**DEVIATION REQUEST** (Attach diagrams, figures, and other documentation to clarify request)

A deviation from the standards of or in Section 2.5.2.C.4 of the Engineering Criteria Manual (ECM) is requested.

PROJECT:  
**ANTELOPE RIDGE AT BULL HILL  
 PUD AND PRELIMINARY PLAN**  
 EL PASO COUNTY, COLORADO  
 AUGUST 2025

SHEET TITLE:  
**DEVIATION EXHIBIT**

**DEV2**  
 SHEET 1 OF 1

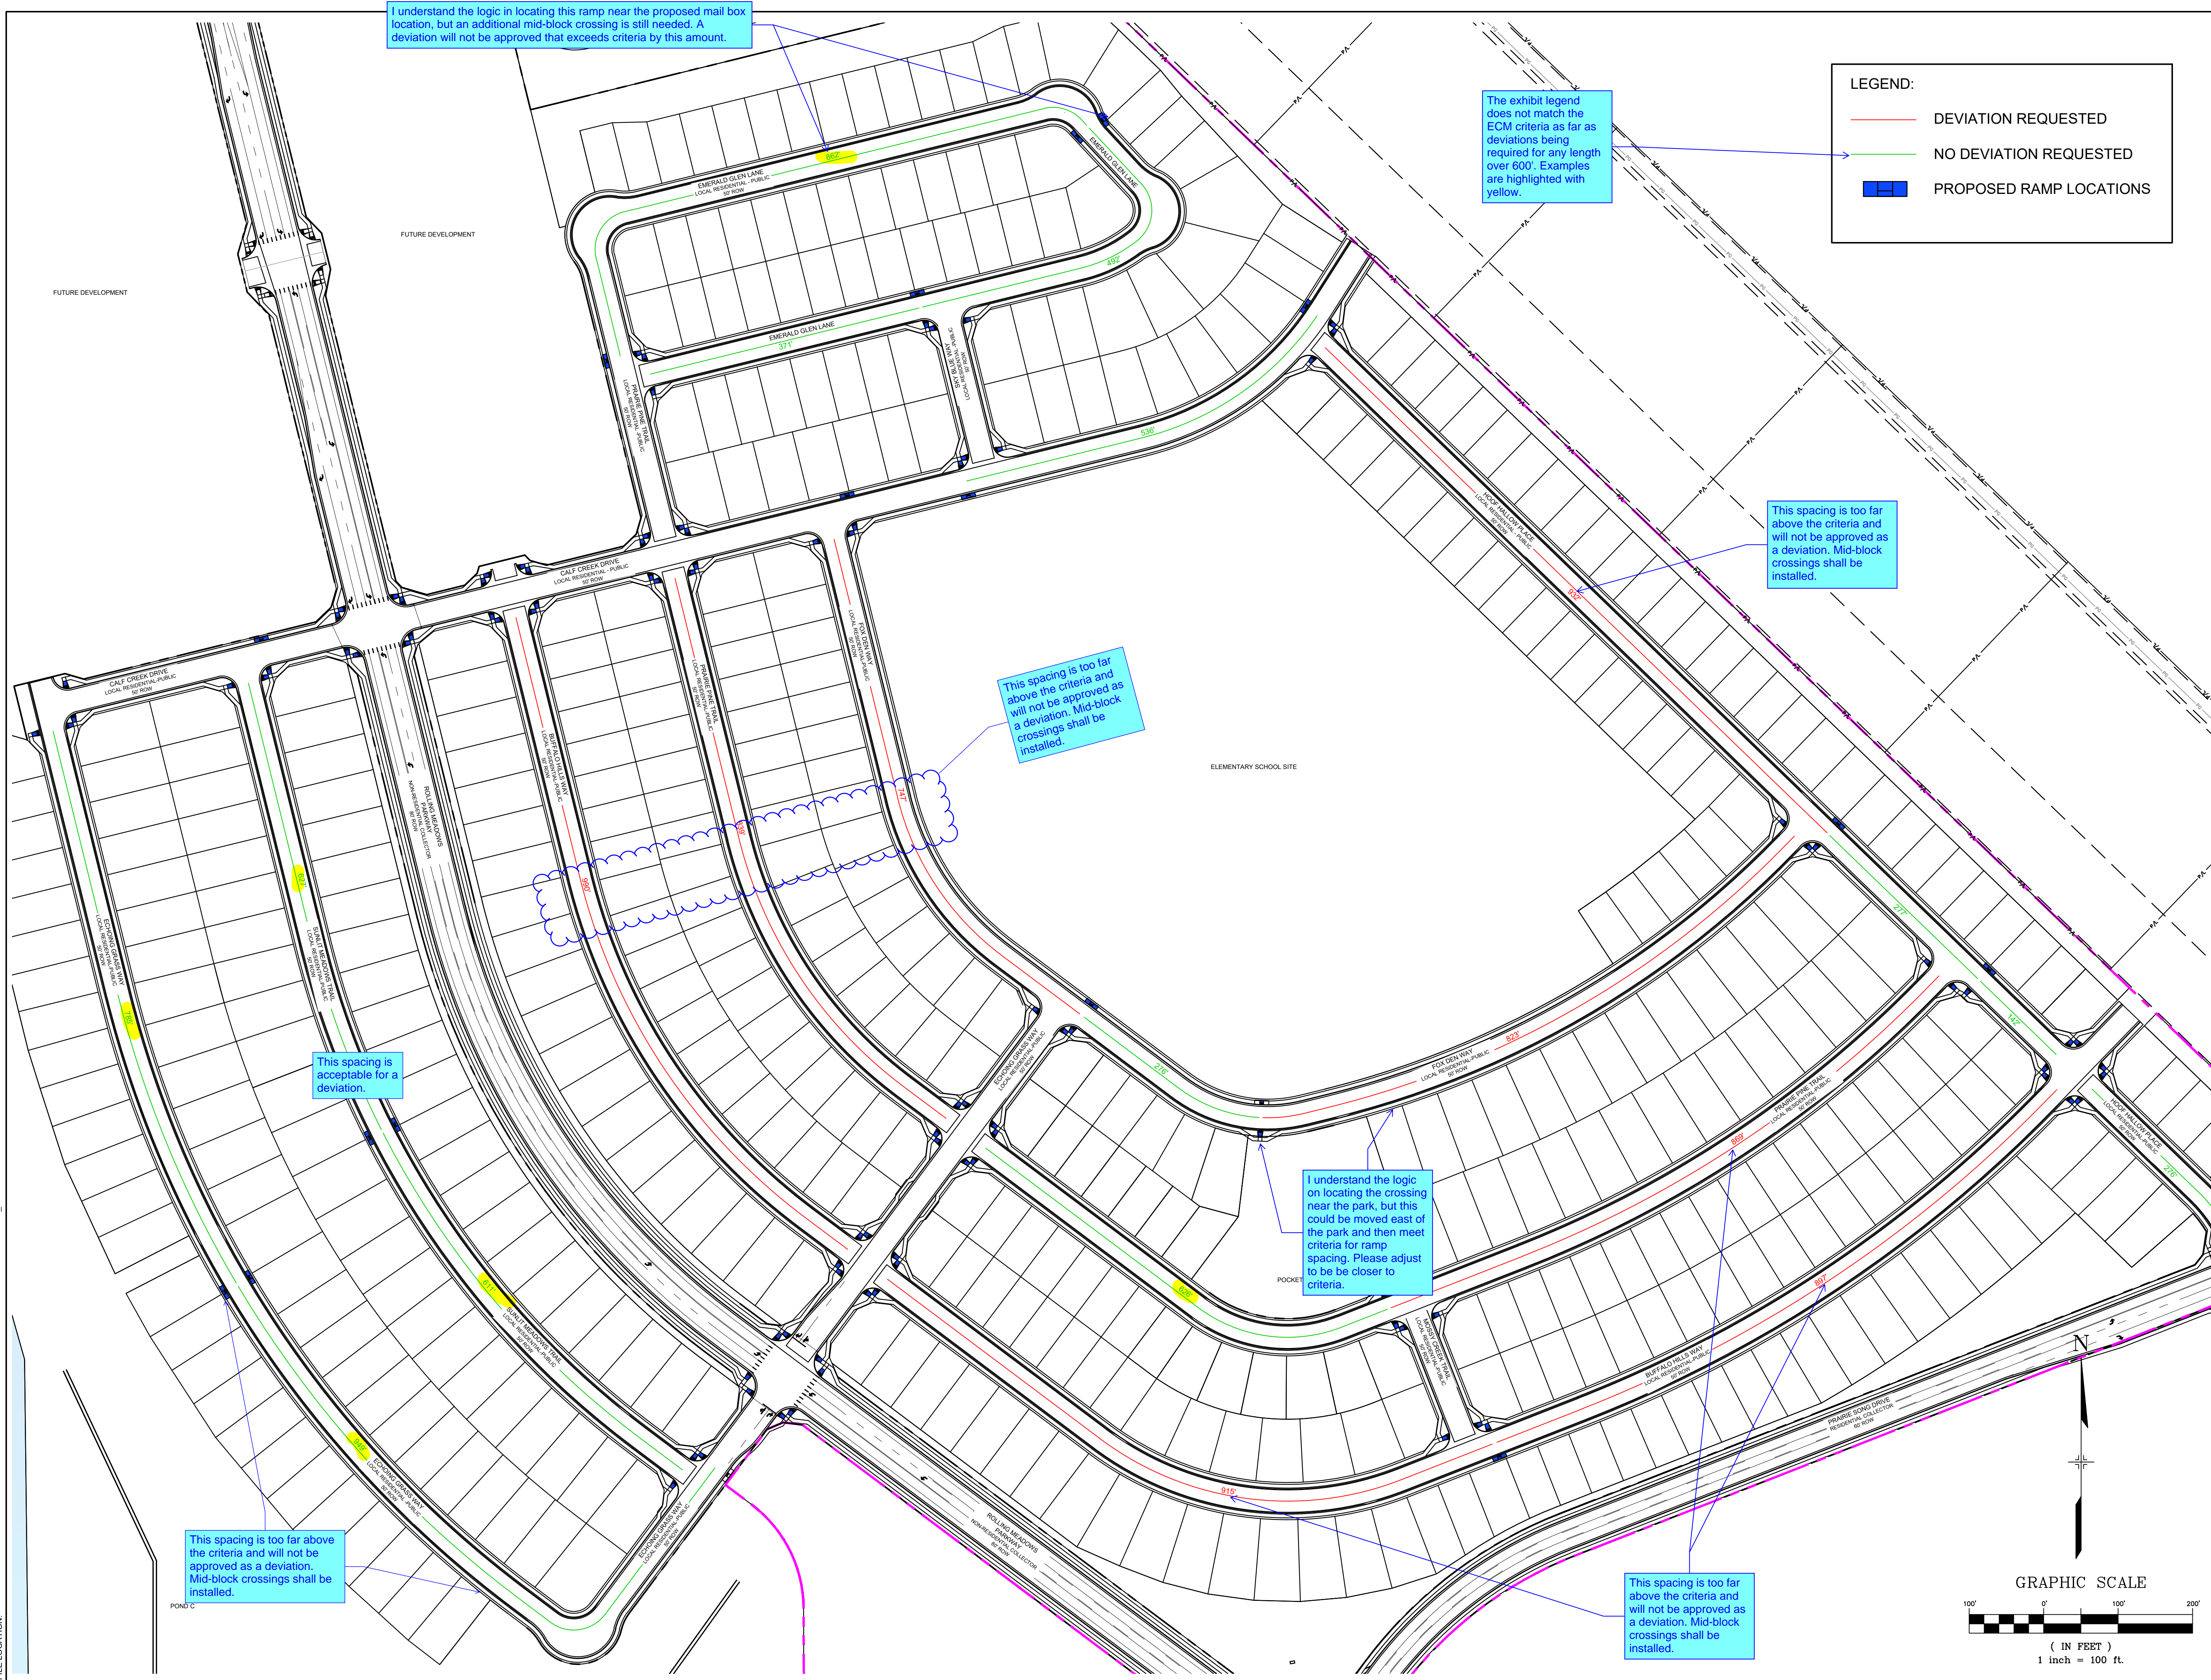
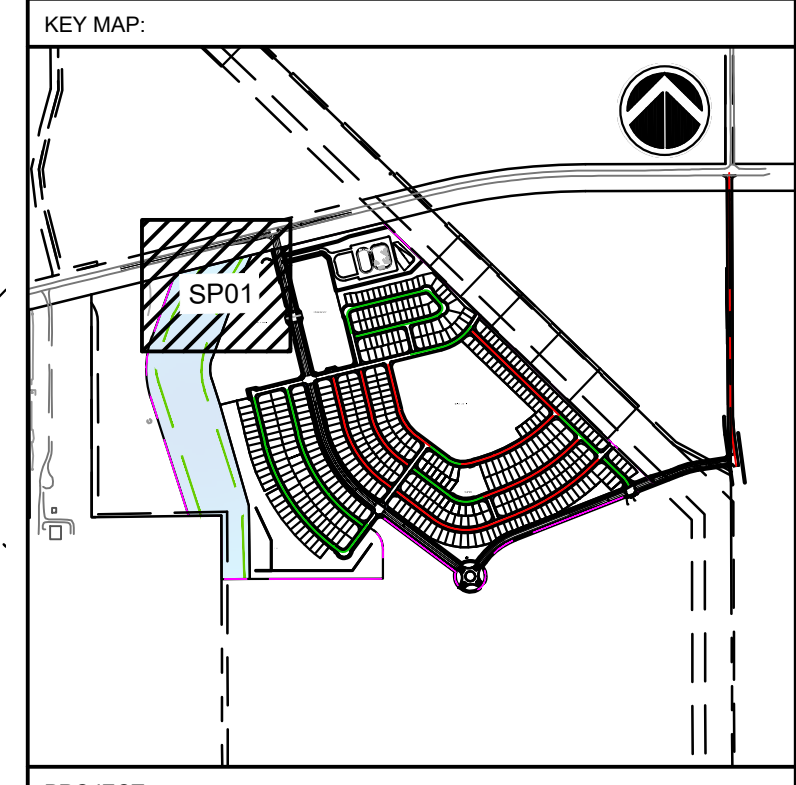
I understand the logic in locating this ramp near the proposed mail box location, but an additional mid-block crossing is still needed. A deviation will not be approved that exceeds criteria by this amount.

The exhibit legend does not match the ECM criteria as far as deviations being required for any length over 600'. Examples are highlighted with yellow.

This spacing is too far above the criteria and will not be approved as a deviation. Mid-block crossings shall be installed.

This spacing is too far above the criteria and will not be approved as a deviation. Mid-block crossings shall be installed.

I understand the logic on locating the crossing near the park, but this could be moved east of the park and then meet criteria for ramp spacing. Please adjust to be closer to criteria.

This spacing is too far above the criteria and will not be approved as a deviation. Mid-block crossings shall be installed.

This spacing is too far above the criteria and will not be approved as a deviation. Mid-block crossings shall be installed.
